APPLICATION FOR PERMIT

LOT PLAN FOR PROPOSED 2ND FLOOR
ADDITION ON CURVE ISLAND, LOT # 109 B E 7

RE: #109-B-F-7 Island Avenue, Cliff Island

Your application to construct a 10' x 16' addition to a dwelling and a second story addition has been reviewed, and a building permit is herewith issued subject to the following requirements.

FRAMING PLAN
ENCLOSURE PART

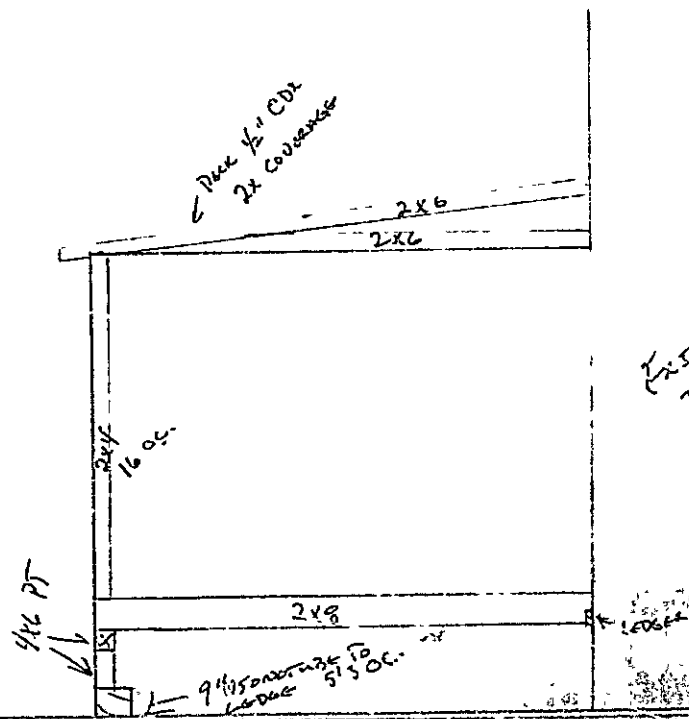
1. Your plan didn't reveal the depth of the sonotubes. The Building Code requires a minimum of 4'0" below grade unless bedrock is closer to grade. A footing should be placed at the base of the tube with an anchor bolt between the two.
